PCN-20210614 TE0784-01 eMMC Change and Product Update

Company	Trenz Electronic GmbH
PCN Number	PCN-20210614
Title	TE0784-01 eMMC Change and Product Update
Subject	BOM change
Issue Date	2021-10-25

Locate eMMC (U15) on bottom side of PCB:

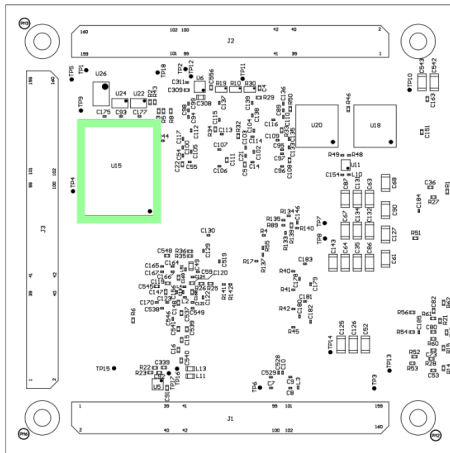
#1 Change eMMC (U15) from IS21ES08G-JCLI to SDINBDG4-8G-XI2

Reason: Distributor informed about unforeseeable immediate EOL of parts. No official documents from manufacturer are available. No LTB, already confirmed orders were cancelled by distributor/manufacturer.

Impact: None. Replacement has same capacity as used on corresponding affected variant. Reference designs for vivado versions 2019.2 and 2020.2 were tested and work properly without any changes.

old	new
IS21ES08G-JCLI	SDINBDG4-8G-XI2
